Temporary Drainage Proposal (Issue 2)

1. Comments from DSD/MN

Temporary Drainage Proposal for
Proposed Temporary Vehicle Repair Workshop with Ancillary
Office and Storage Use for a Period of 3 Years at
Lot 3278 RP in D.D 104, Mai Po Yuen Long, New Territories

Approved Drainage Proposal
s16 No. : A/YL-MP/405

PROPOSED DRAINAGE WORKS

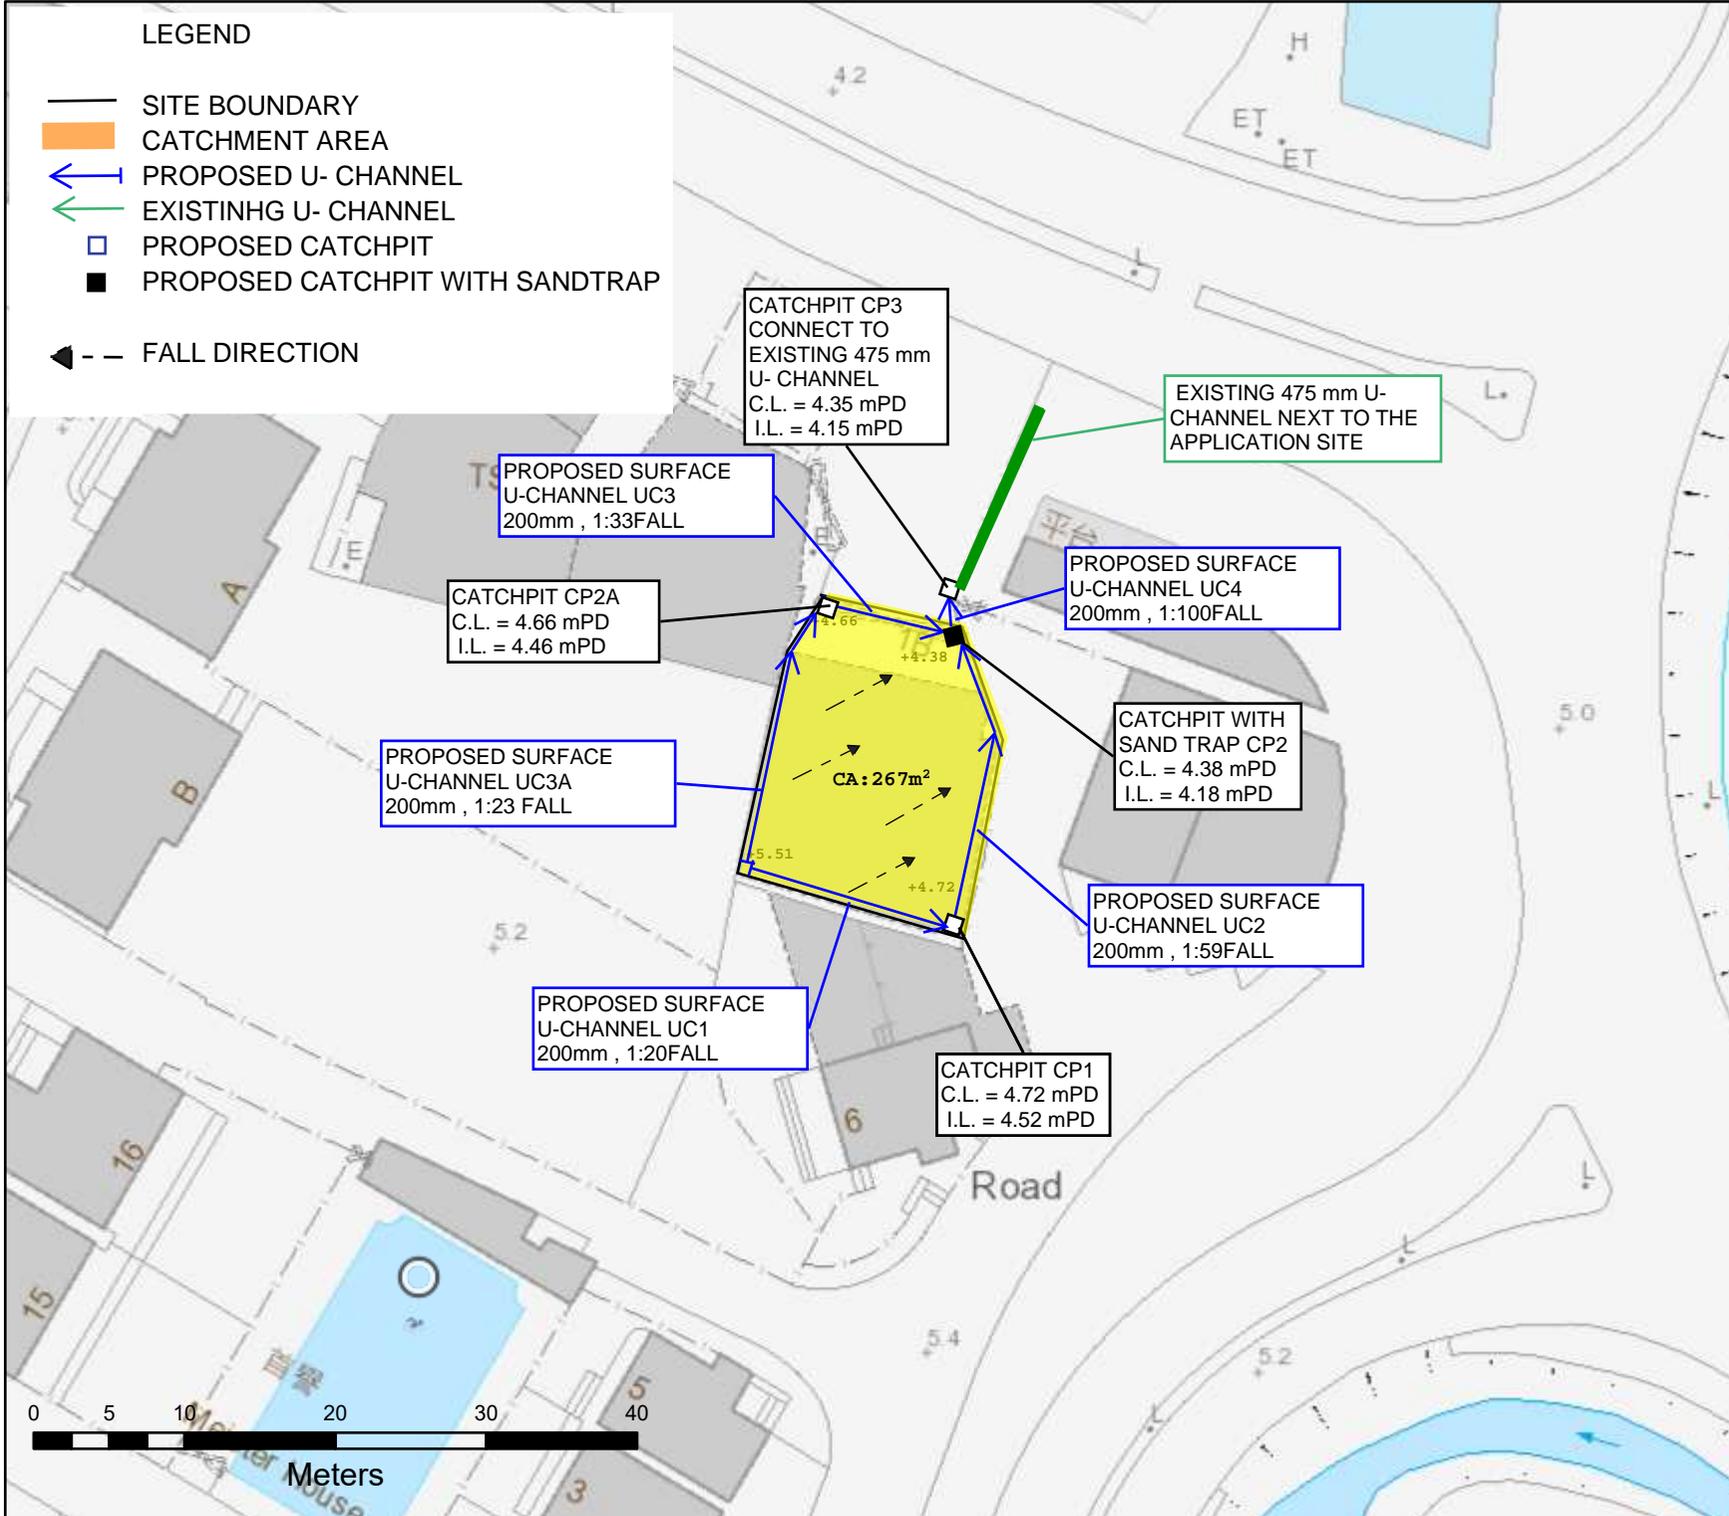
3.	Peripheral drains should be provided for the application site to collect surface runoff.	Noted and surface channel UC3A is added. Please refer to updated Appendix D.

5.	Please advise and indicate where is CP3.	Noted and appendix D is updated.
6.	Please provide evidence to show the dimension of existing 475UC.	Please refer to updated Appendix C.

7.	The cover and invert levels of the proposed u-channels and catchpits should be shown on the drainage plan.	Noted and appendix D is updated.
8.	The existing drainage facilities, to which the stormwater of the development from the subject site would discharge, are not maintained by this office. The applicant should identify the owner of the existing drainage facilities to which the proposed connection will be made. Also, Drainage Services Department noticed that the proposed drainage connection(s) to the surrounding/downstream area(s) will run through other private lot(s). The applicant shall demonstrate that the proposed drainage construction /improvement /modification works and the operation of the drainage can be practicably implemented.	Noted and the owner of the existing drainage facilities will be identified and notified.

Appendix D2 Sections of Application site

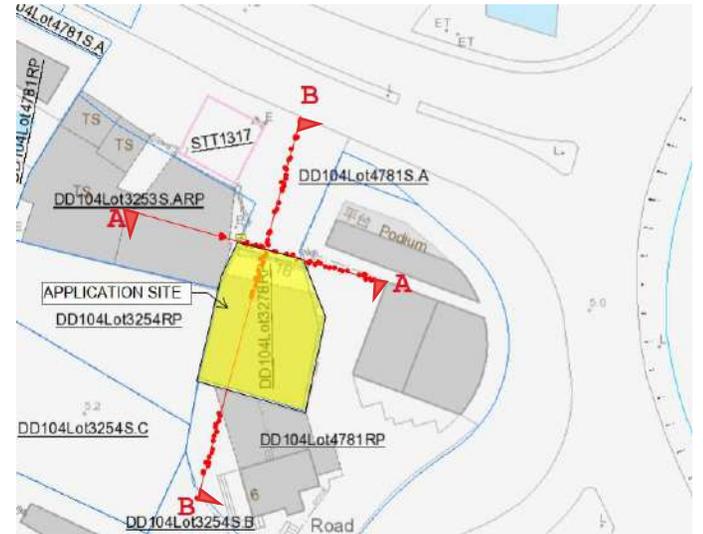
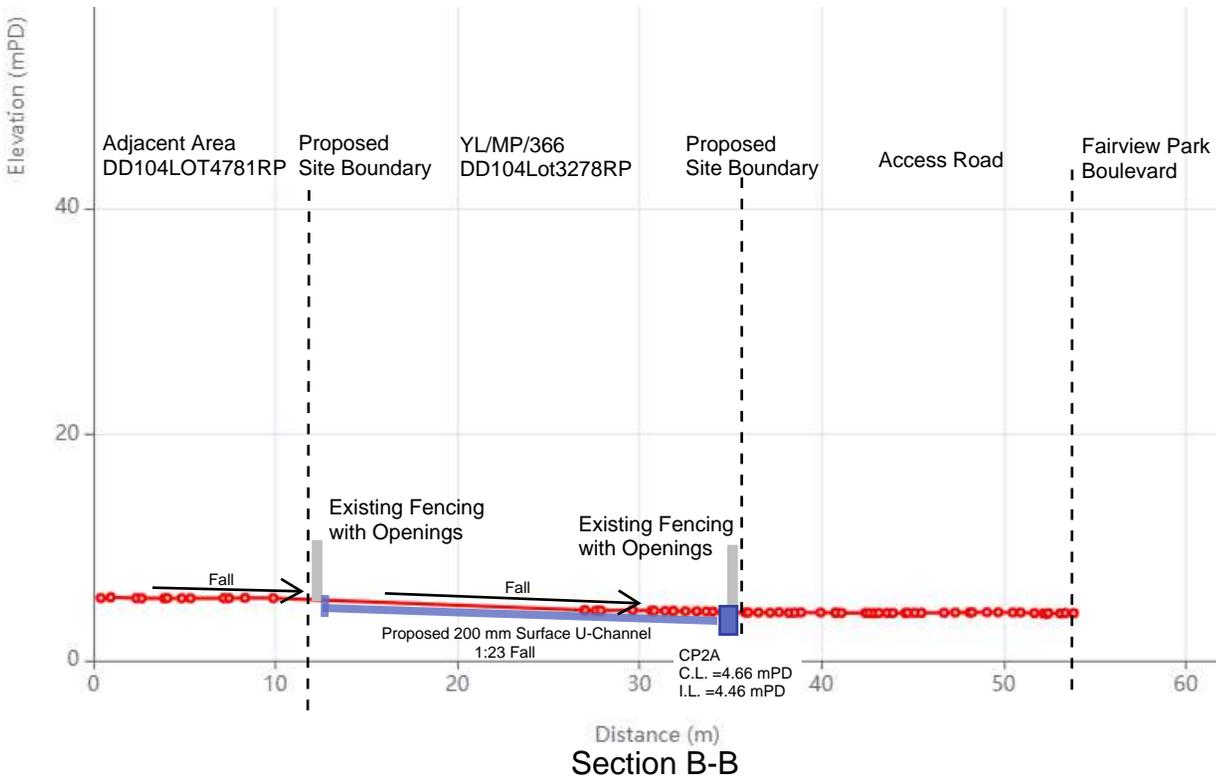
10.	Cross sections showing the existing and proposed ground levels of the captioned site with respect to the adjacent areas should be given.	Noted and please refer to updated Appendix D.
